Remarks/Arguments

Serial No. 10/600,233

Amendment A

Reply to Office Action of June 15, 2004

FIG. 1

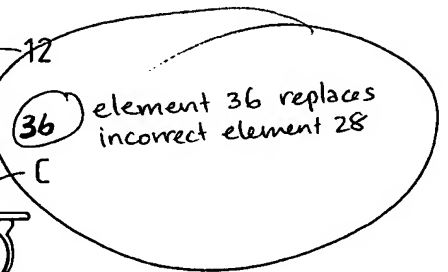
The Examiner objected to the drawings for a number of reasons. First, the Examiner objected to the drawings because they do not include the following reference characters included in the specification: 10 (strapping machine); 36 (hub); and 40 (top edge). Applicant has amended FIGS. 1-4 to show these reference numerals.

Next, the Examiner objected to FIGS. 1 and 3 because they include reference numeral 28, which is not mentioned in the specification. Applicant has amended FIGS. 1 and 3 to remove this inaccurate reference numeral, replacing it with 36, the correct reference number.

FIG. 4

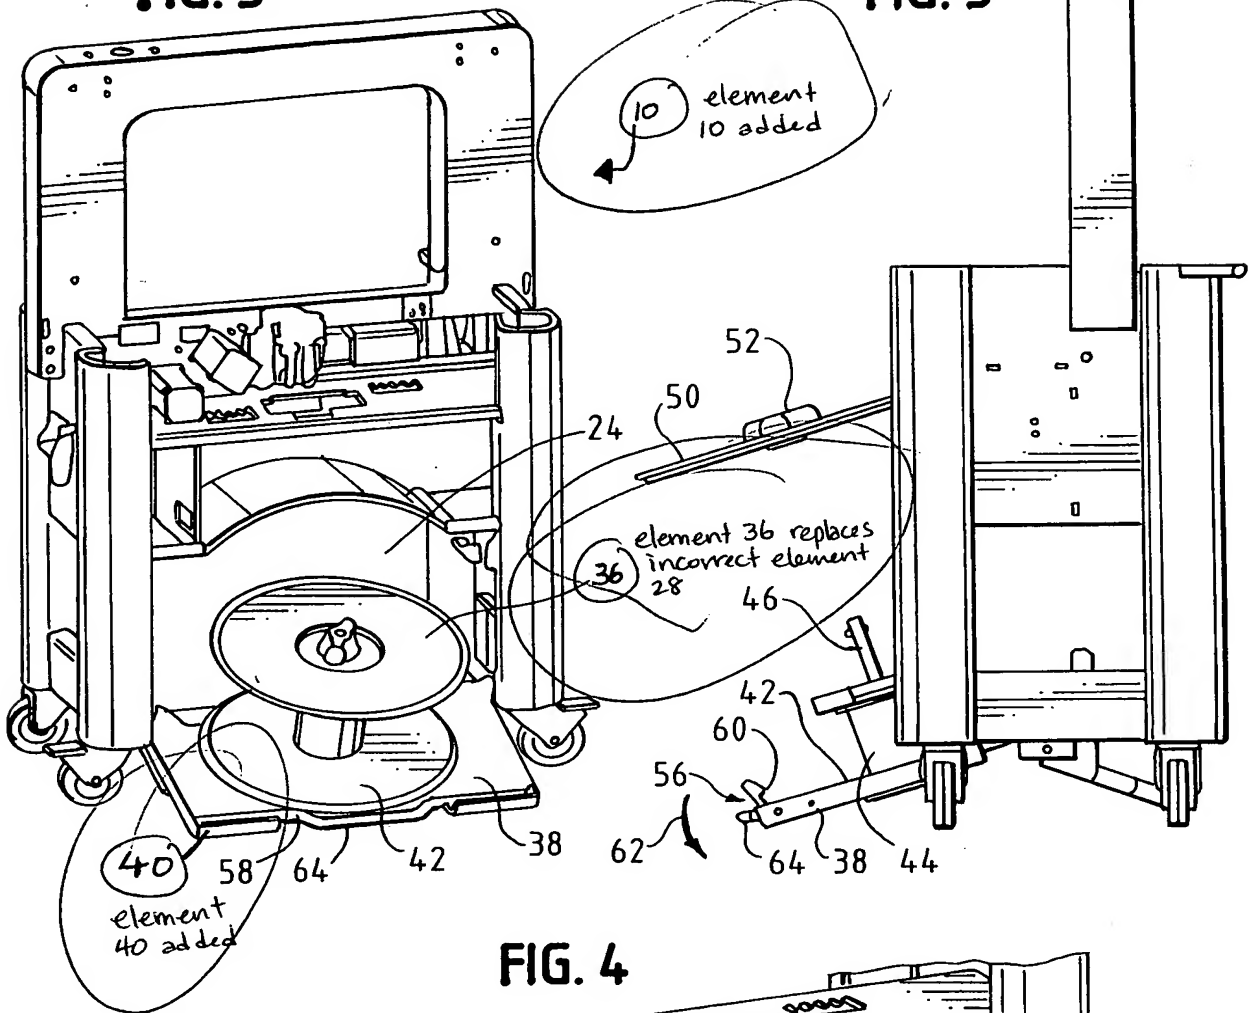
Finally, the Examiner objected to FIGS. 4 and 5 because they were photographs. As discussed above, Applicant has furnished replacement black ink formal drawings for FIGS. 4 and 5.
